**PLANNING AND ZONING AND COUNTY COUNCIL INFORMATION SHEET**  
Planning Commission Public Hearing Date: October 27<sup>th</sup>, 2022

Application: 2022-03 Paradise Meadows

Proposed Use: 191 single-family lots as a Cluster Subdivision

Subject: **Preliminary Plans for Paradise Meadows**

**GENERAL NOTES & DETAILS  
PRELIMINARY PLAT**  
FOR  
**PARADISE MEADOWS**

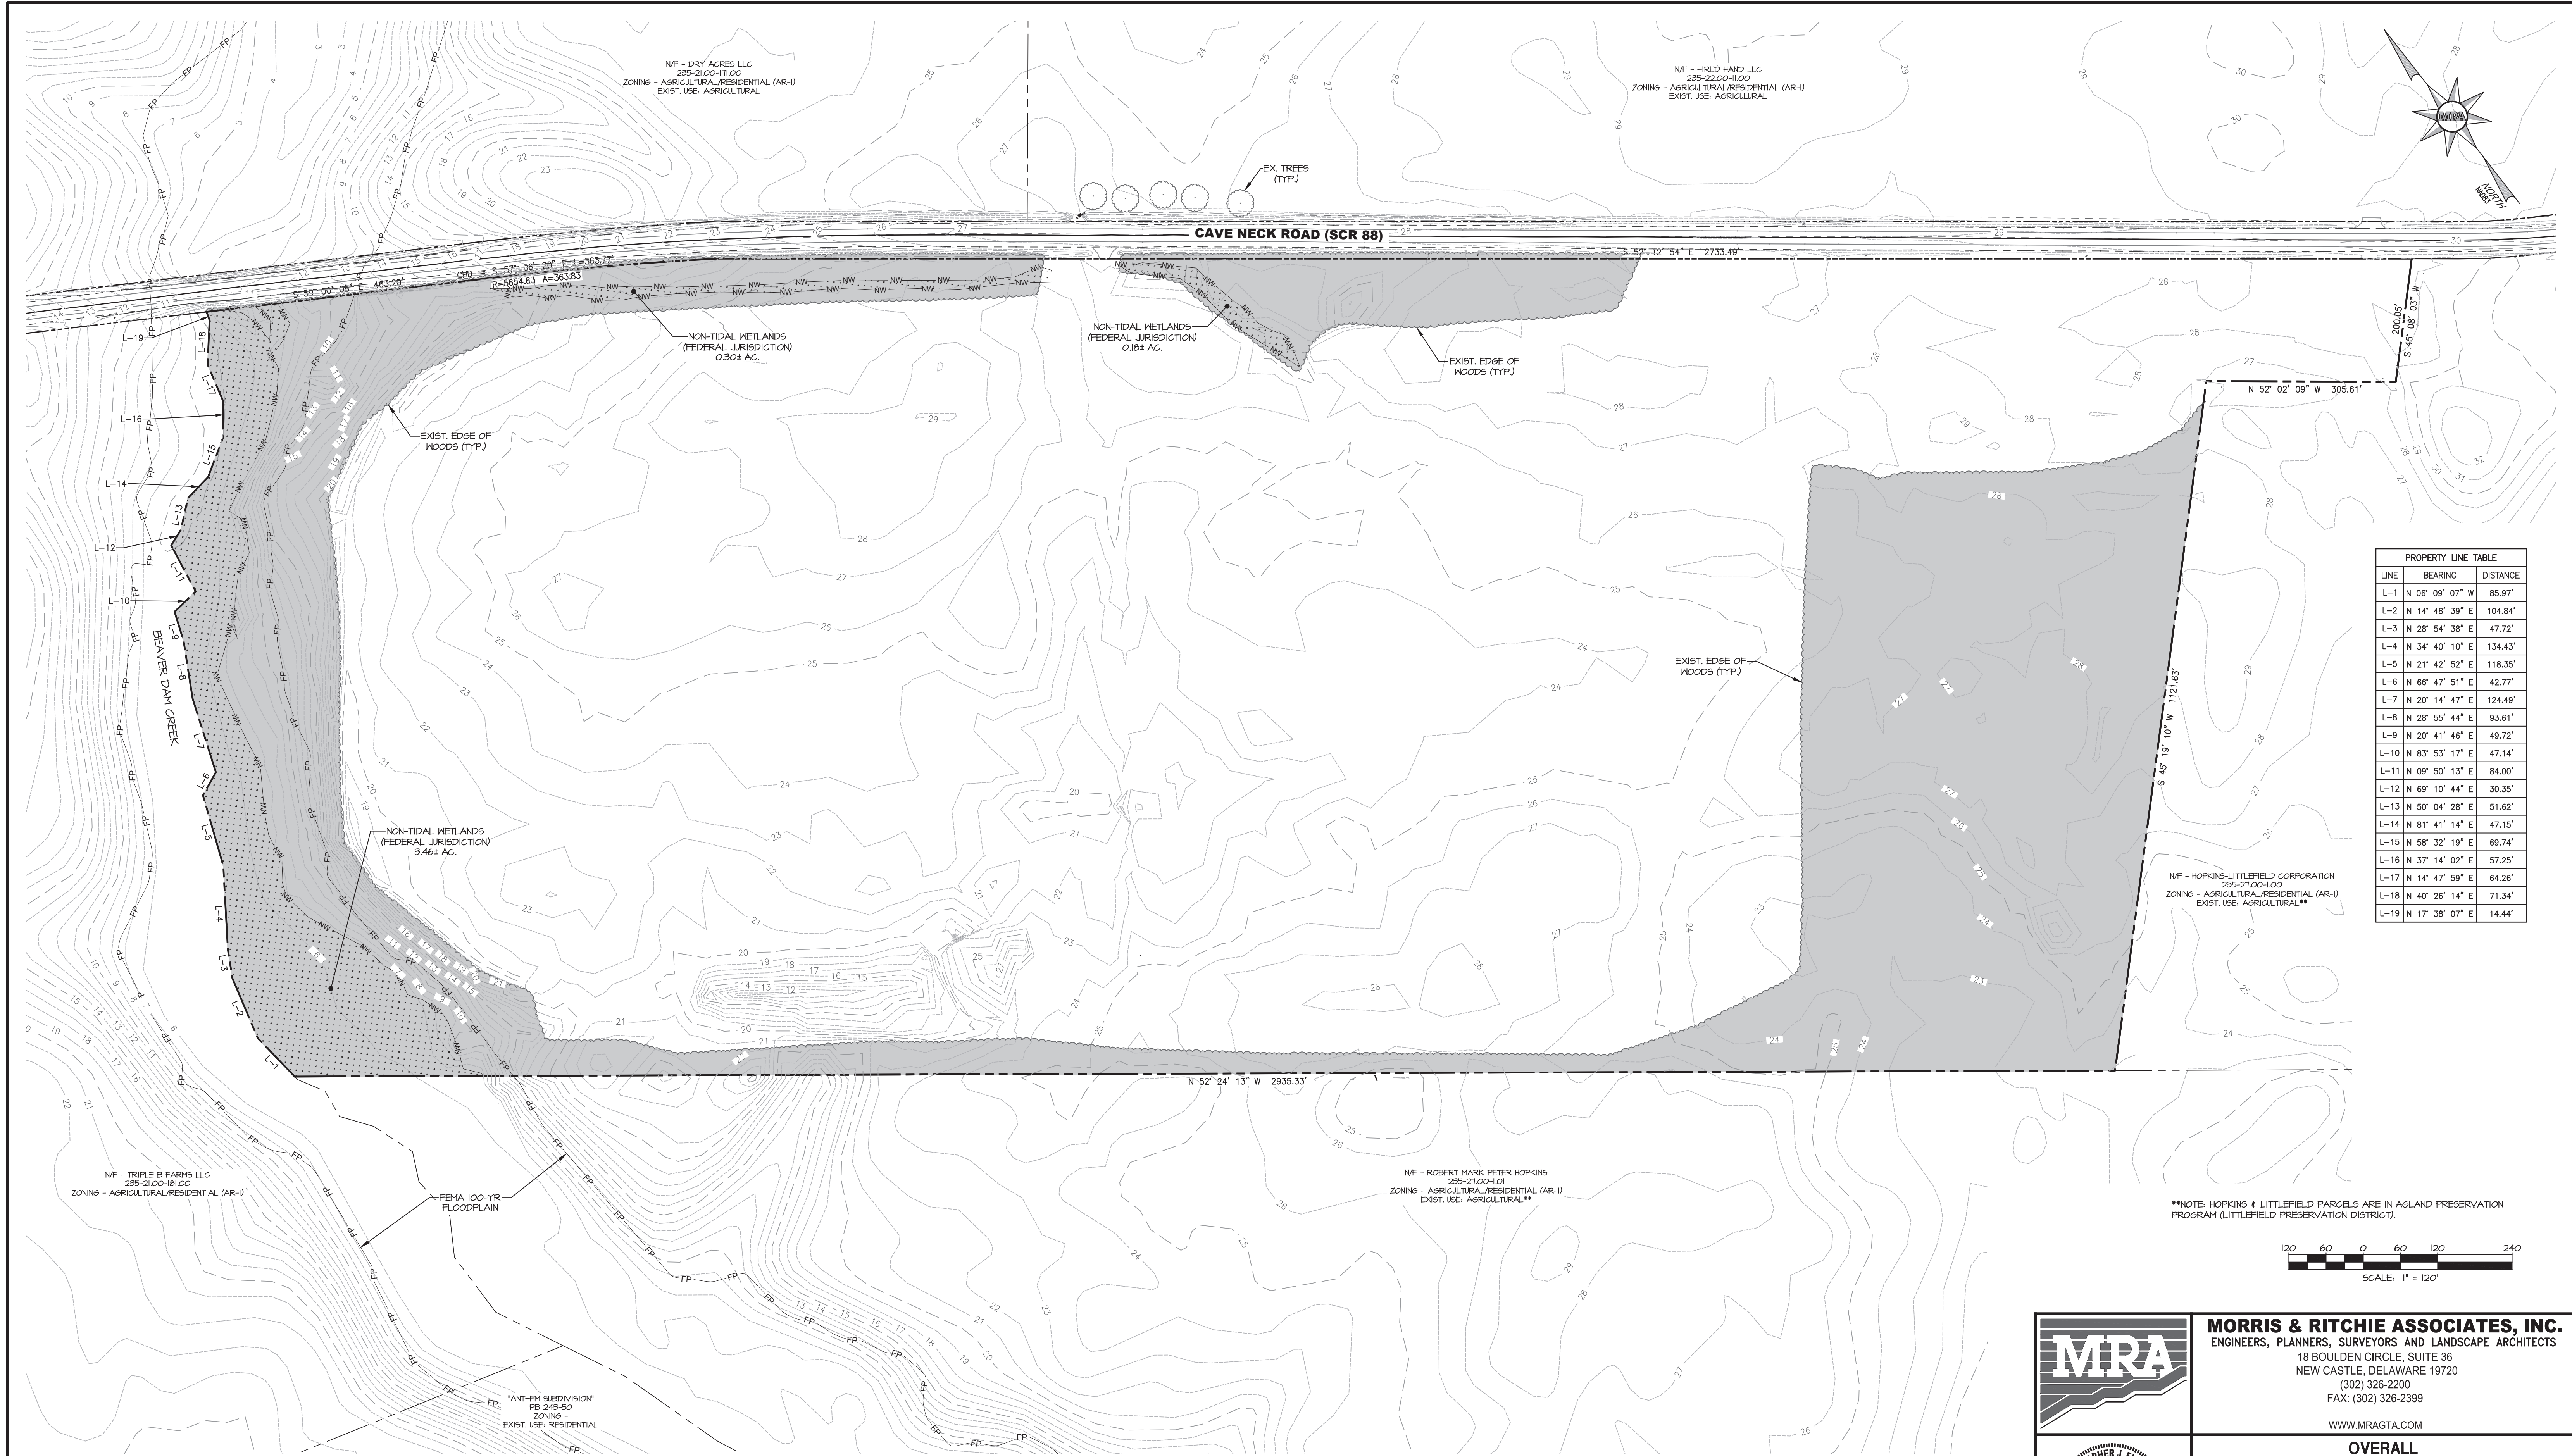
13. Please amend the minor typographical error in the Project Phasing Notes on Sheet #2 from “The project is be approved...” to “The project is to be approved...”

*Comment 13: Please amend the minor typographical error in the Project Phasing Notes on Sheet #2 from "The project is be approved..." to "The project is to be approved..."*

Response: Comment addressed; no deed restrictions are anticipated at this time. General Note #8 has been added to Sheet 2 reflecting this condition.

Response: Comment addressed; forested buffer strip areas are located within the community open space areas. As a common facility, these areas are to be maintained by the community association. General Note 7 on Sheet 2 has been revised to note this requirement.

DATE	REVISIONS	JOB NO.:
10/01/22	REV. PER SUSSEX P&Z / TAC COMMENTS	21482
		SCALE: 1" = 50'
		DATE: 1/21/22
		DRAWN BY: CMT
		DESIGN BY: CMT
		REVIEW BY: CJF
		SHEET: 8 OF 9

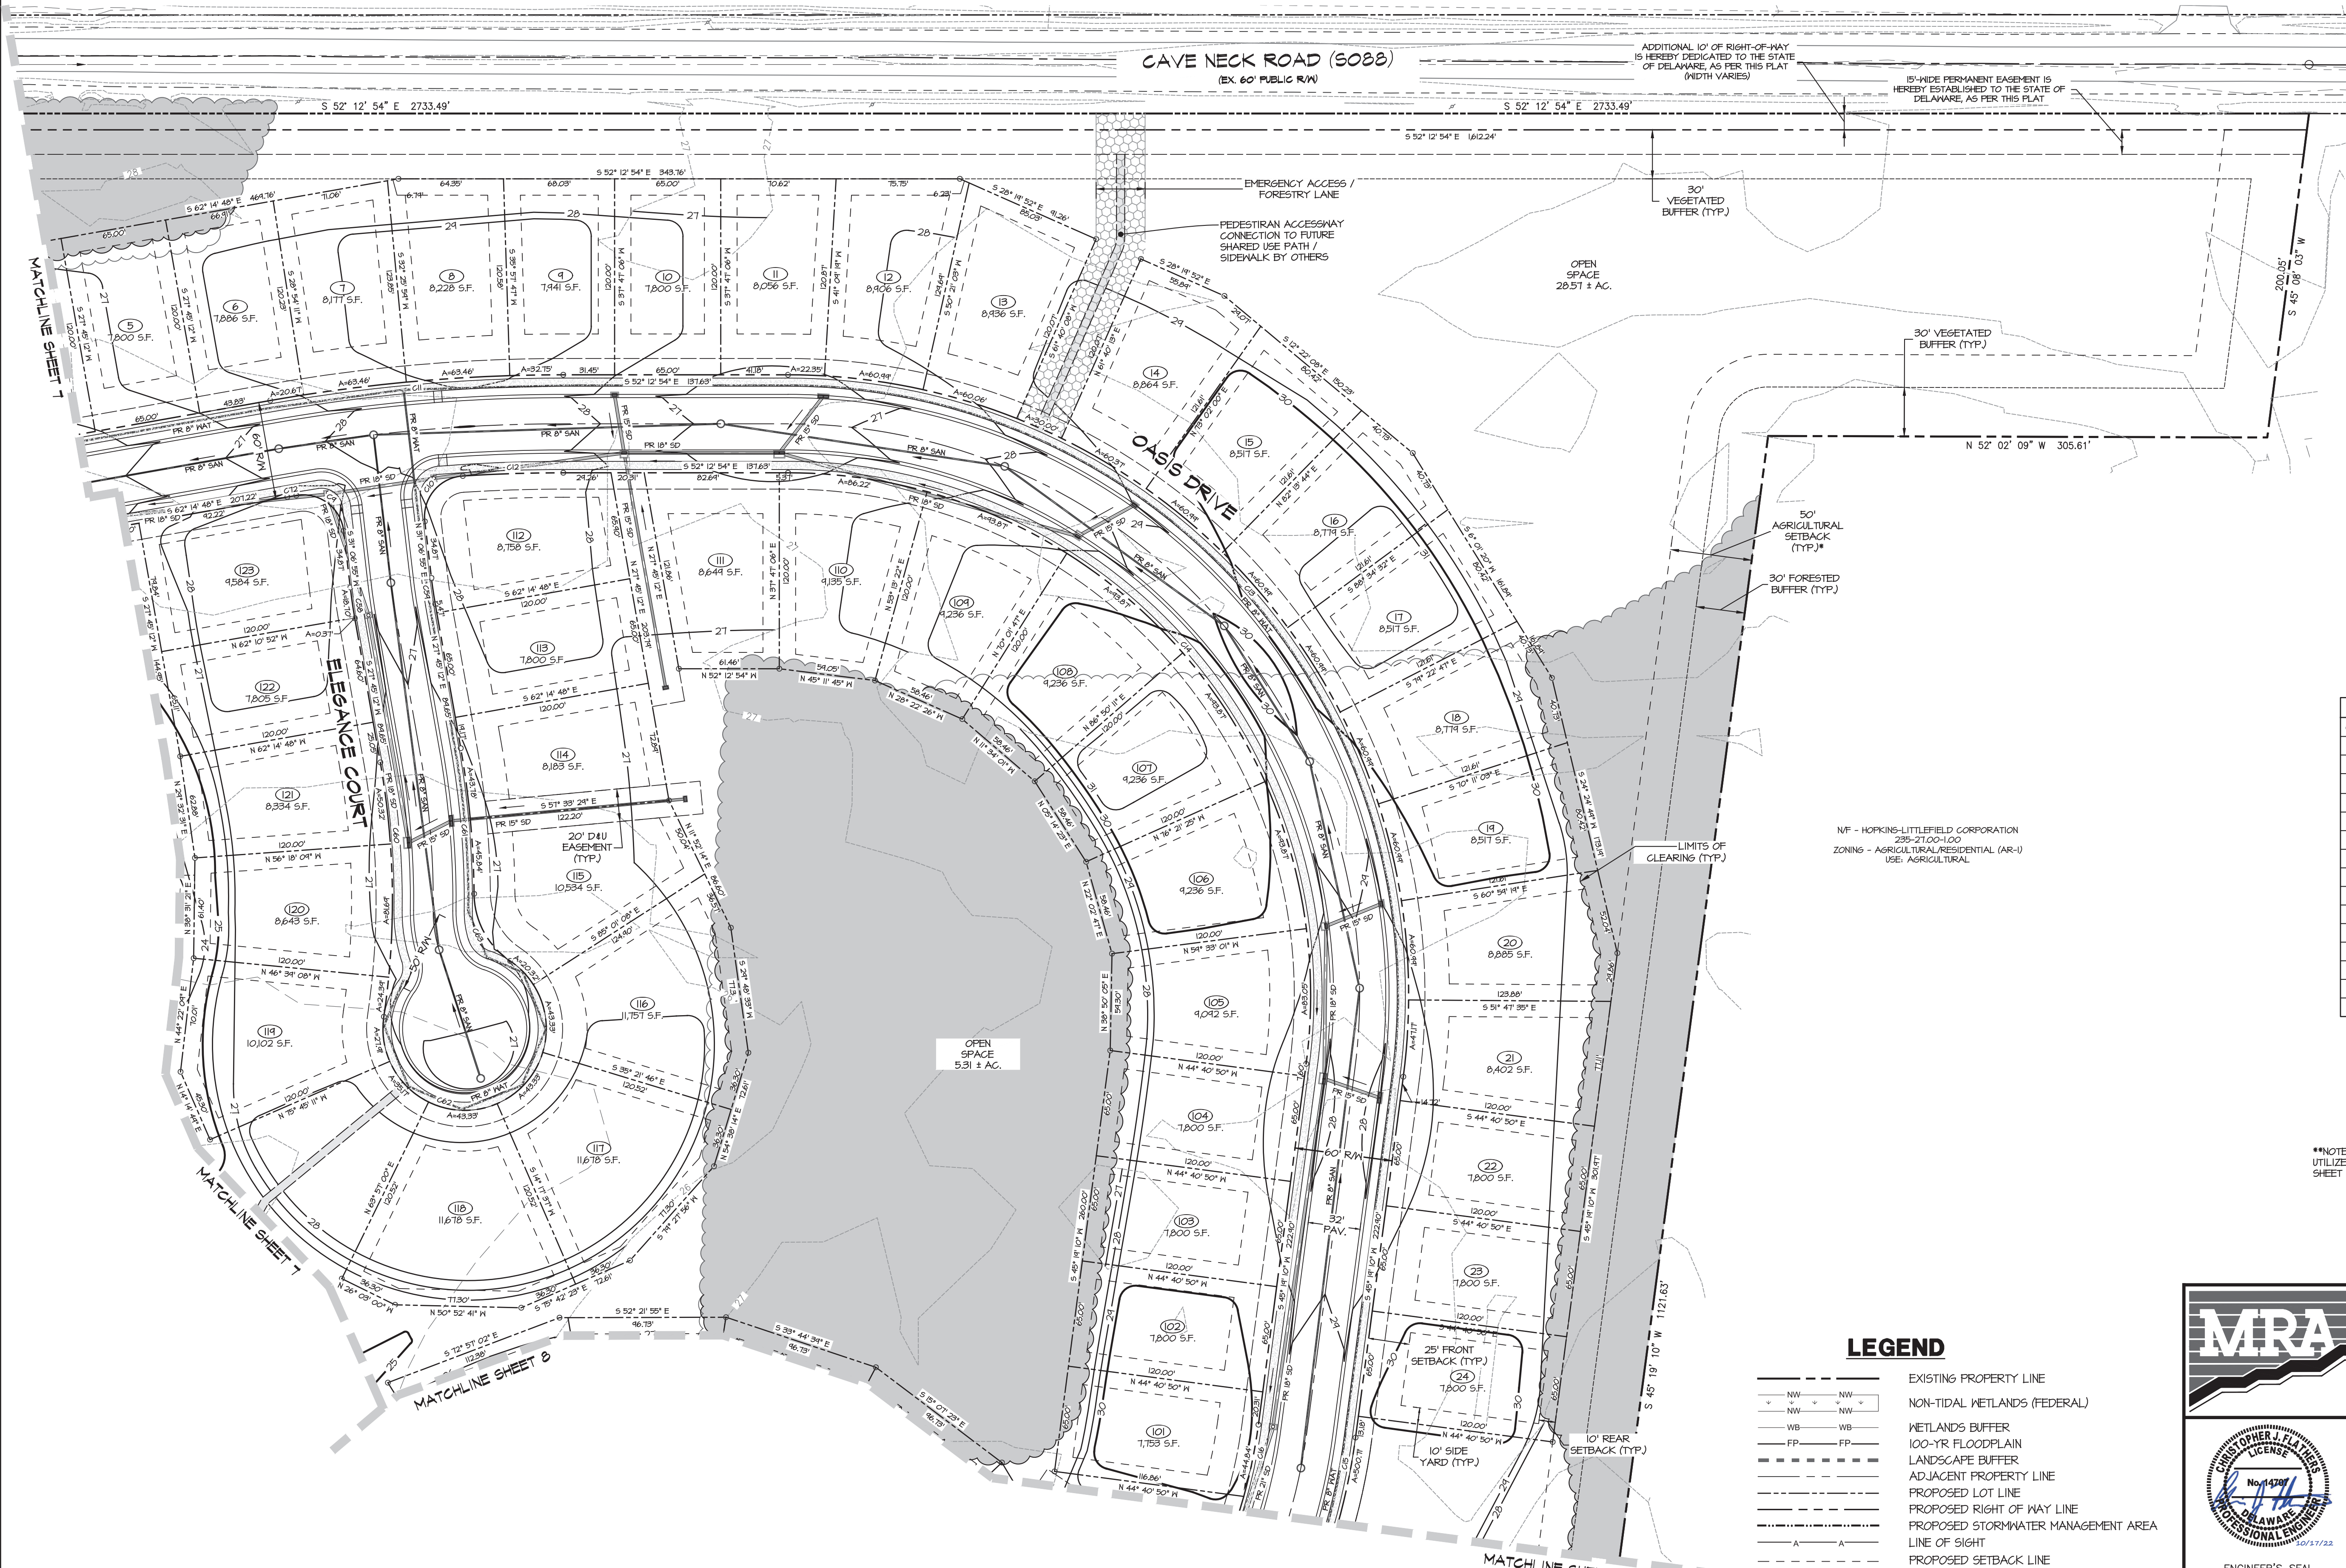
10. **Please clarify that the 10-ft front setback shown on Sheet 8 is shown for purposes of delineating the required 10-ft utility easement for the property and that this is not the front yard setback being proposed for the subdivision (as this should be a minimum of 25-ft.)**

*Comment 10: Please clarify that the 10-ft front setback shown on Sheet 8 is shown for purposes of delineating the required 10-ft utility easement for the property and that this is not the front yard setback being proposed for the subdivision (as this should be a minimum of 25-ft.)*
